PRODUCT CHANGE NOTICE

Part Marking Configuration Change for Intersil TDFN, uTDFN, and uTQFN Packaged Products

**Refer to:
PA10114**

Date: November 10, 2010

POD 1.2 x 1.0 - Single Digit Part Code

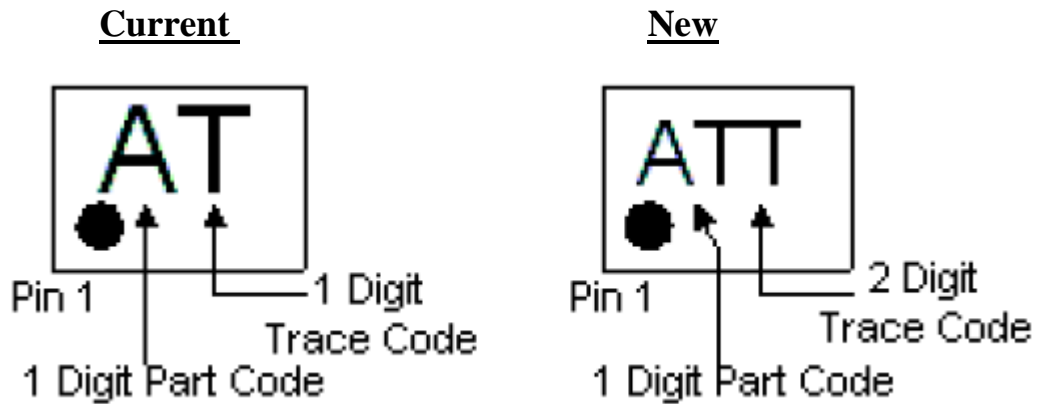
This notice is to inform you that Intersil is changing the configuration of the “top side” marking (brand) for the listed TDFN (Thin Dual Flat No-lead), uTDFN (Ultra Thin Dual Flat No-lead), and uTQFN (Ultra Thin Quad Flat No-lead) plastic packaged products. The restructured layout allows for the marking of additional characters in support of enhancing product traceability. There will be no change to the product code that is currently marked on the device. Examples of the current and new marking configurations are included for reference.
